SIB 61 10 22

SERVICE ACTION: REWORKING THE REAR POWER DISTRIBUTION BOX

This Service Information Bulletin (Revision 2) replaces SI B61 10 22 **dated May 2022**.

2. Locate and disconnect the blue connector (**Z2*1B**) from rear power distribution box.

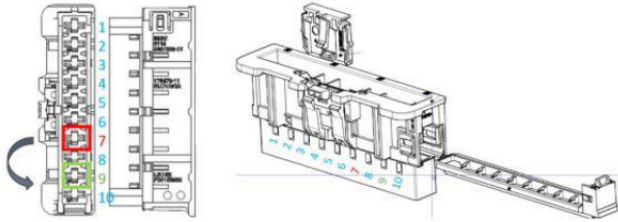
4. De-pin RT/WS female terminal wire from pin 7.

5. Relocate RT/WS female terminal wire to pin 9.

6. Reconnect the blue connector (**Z2*1B**) to rear power distribution box. Install a new blade-style 40 A fuse into slot **F229**.
